Proposal for Supplement 3 to the Original Version of UN Regulation No. 158 (Devices for means of rear visibility or detection)

The text reproduced below was prepared by the expert from the Republic of Korea. The modifications to the current text of UN Regulation No. 158 are displayed in bold for new or strikethrough for deleted characters.

Figure 1. example of cargo truck tailgate.

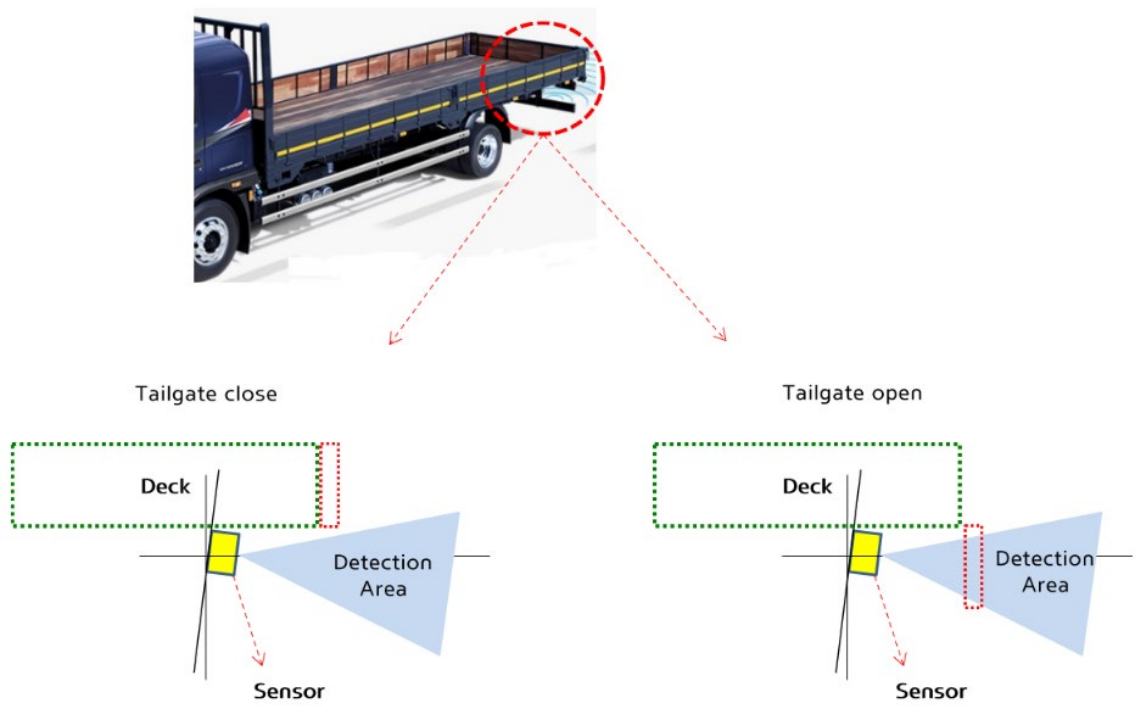
2. In addition, the test conditions should specify that not only rear hatches or trunk lids but also the tail gates of cargo trucks and van-type vehicles should be closed or latched in their normal vehicle operating condition during the test. For additional information on this matter, please refer to the following figures.
